Model 2450 SourceMeter Instrument

Version 1.7.7 Firmware Release Notes

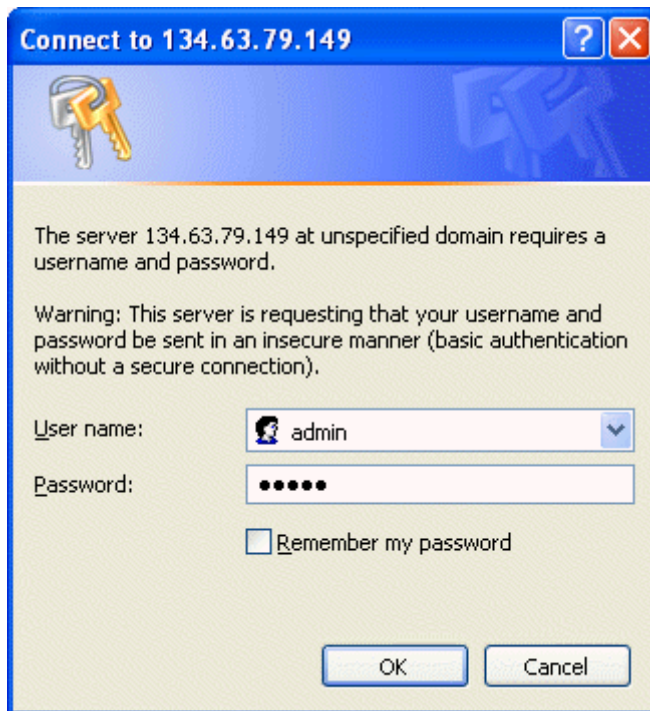
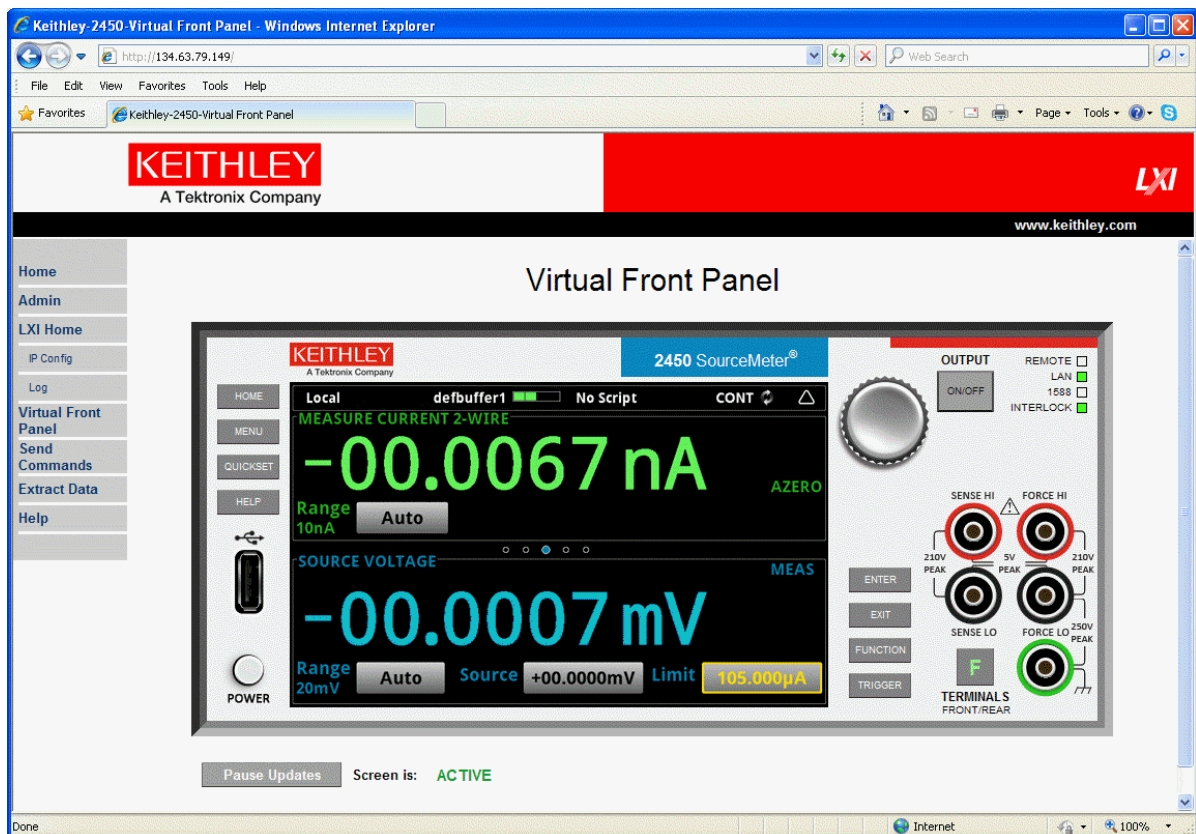
Implement new Virtual Front Panel capability.

To access the new Virtual Front Panel, access the 2450 through Ethernet using your favorite Internet browser.

When asked for a Username and Password: enter the Username and Password for that particular 2450. The default Username is `admin` and the default Password is `admin`.

An example of the 2450 Virtual Front Panel is shown below. Users can use their mouse from a standard PC to control the instrument. Users can also use touch screens from most touch screen devices that can access the 2450 IP address.

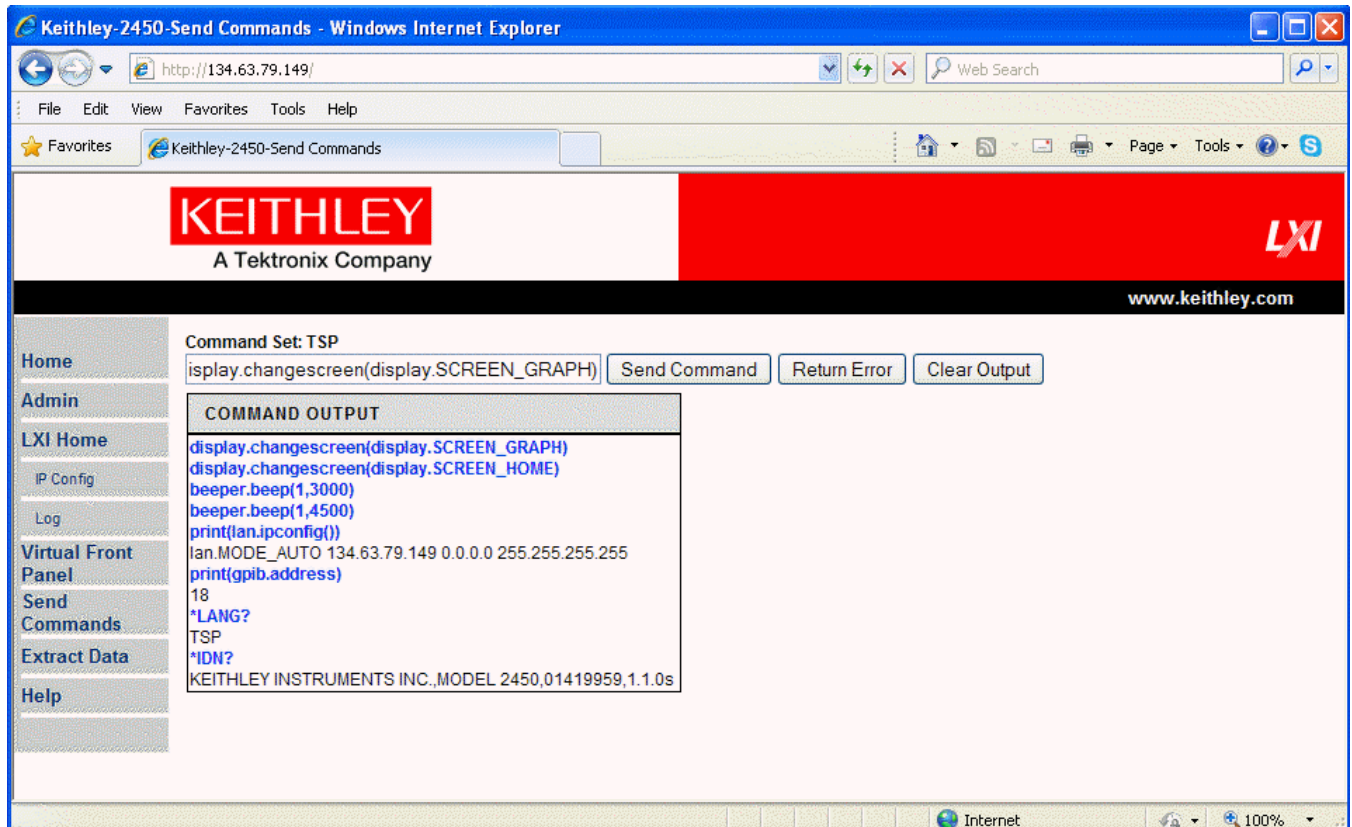
The behavior of the *LANG? command on the 2450 has been changed as follows.

Sending the query *LANG? over a non-controlling interface will no longer change the interface control of the unit. For example, if the unit is under local control, then sending the *LANG? over Telnet, USB, or GPIB will leave the unit under local control. This was done in order for KickStart (or any other remote control software) to query connected/accessible instruments without resetting them or changing or disturbing the current trigger model.

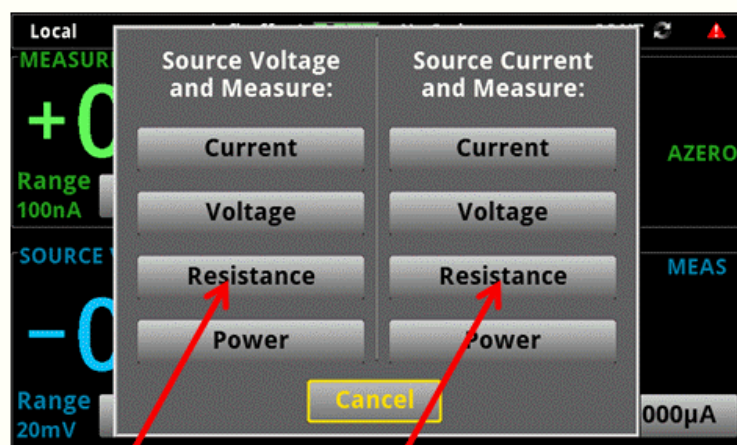
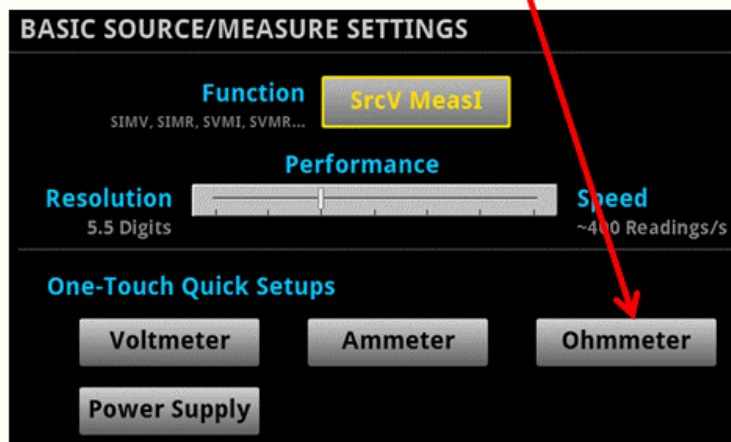
<see the following figure for details>

Both exhibit "Manual" Ohms behavior
(works just like Power by setting units to Ohms and going to SVMI or SIMV)

Exhibits "Auto" Ohms behavior
